# CITY OF BERKLEY, MICHIGAN REGULAR MEETING OF THE CITY PLANNING COMMISSION

Tuesday, August 23, 2022 7:00PM — City Hall Council Chambers Information: 248-658-3320

Subject: SP-14-22; 3860 Twelve Mile Rd., America's Stamp Stop – Site Plan Review

Subject: PSP-10-22 Vinsetta Garage Eaton and Oxford Parking Lots Site Plan Approval

Landscape Plan

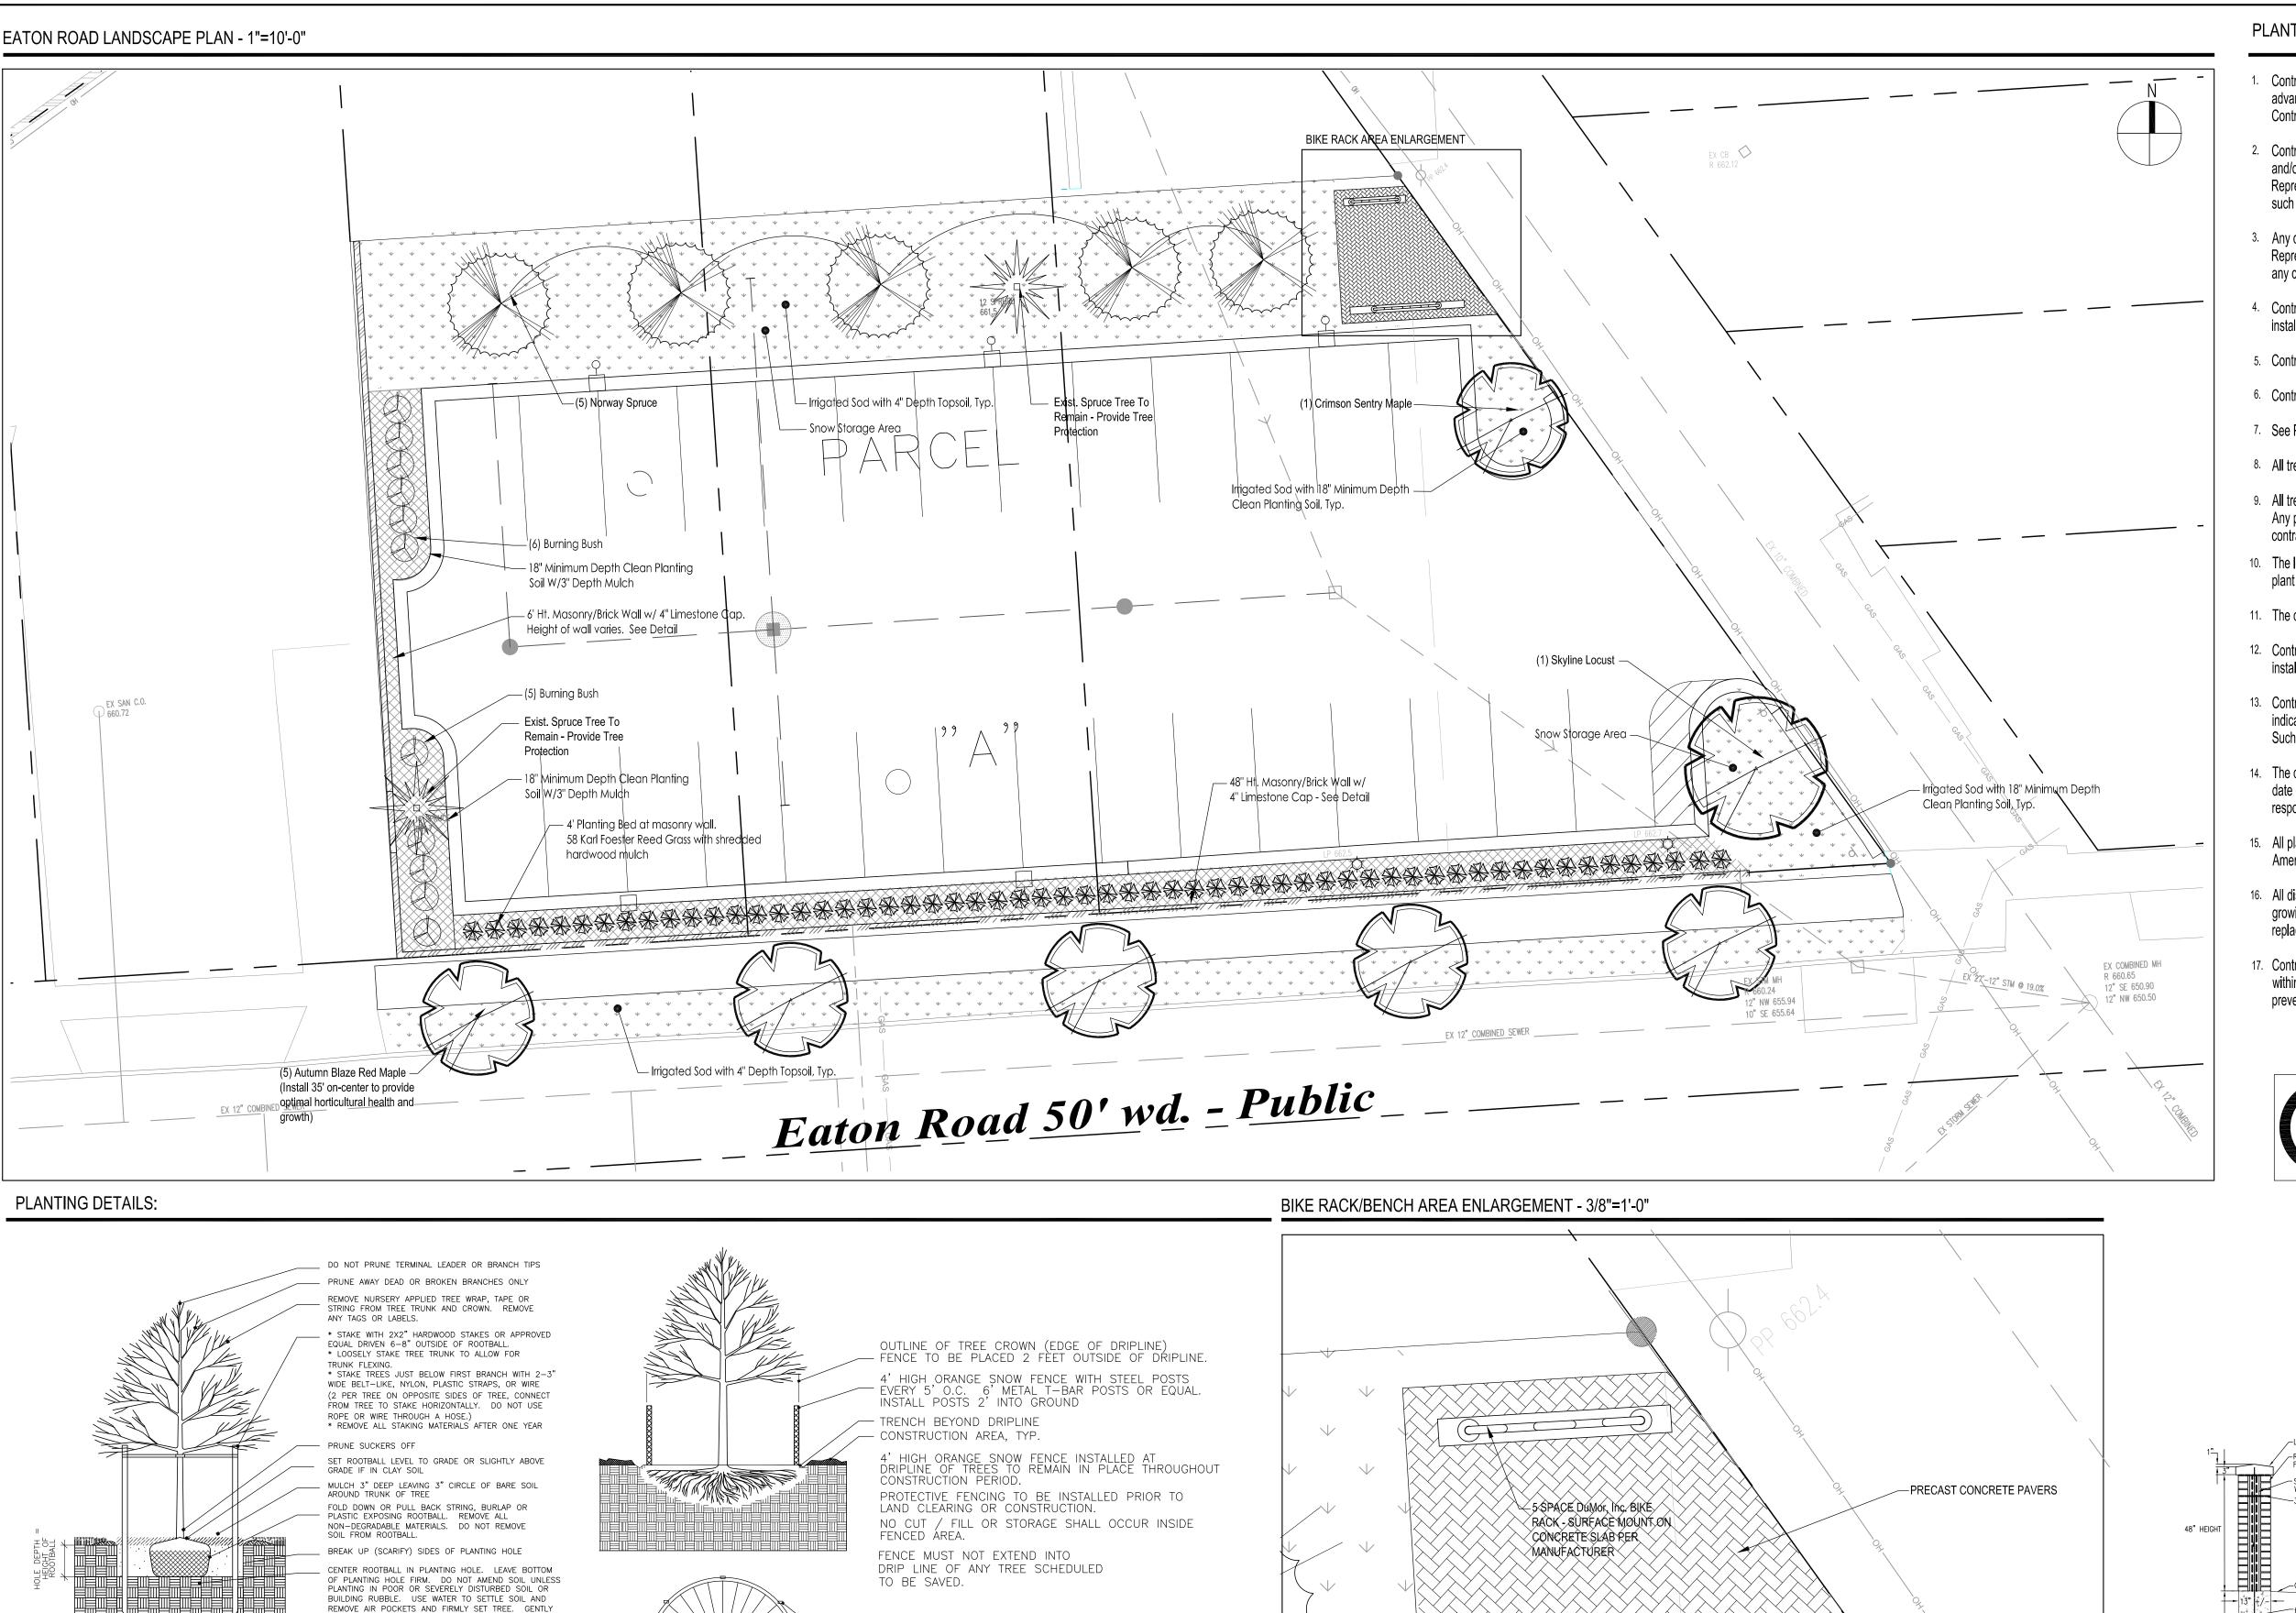
- The limited width of the buffer and the low growing profile of the plants does not provide a sufficient buffer.
- There is no internal landscaping within the parking lot.
- Burning bush is a non-native, invasive species. We recommend that these be replaced with native species of the same size and growth pattern, such as chokeberry.
- The applicant is providing 17-foot buffer along the northern property line. The buffer
  does not seem to have a purpose, and the future use of this area may be parking. We
  know the current and anticipated future use of the property to the west is single-family
  residential. A more practical application of additional screening would be along the
  western property line.

Can the applicant reconfigure the parking lot to add more internal landscaping and a greater buffer along the western property line? If this requires reduction/elimination of landscape buffer along the northern property line, it is worth the tradeoff, and the applicant can maintain the required 28 spaces.

In addition, there small planting area in the northwest and southwest portion of the parking lot. We recommend that the burning bushes proposed be replaced with a native species, such as chokeberry. The applicant proposes three (3) ginkgo trees and one (1) locust adjacent to the alley and four (4) maple trees along Oxford.
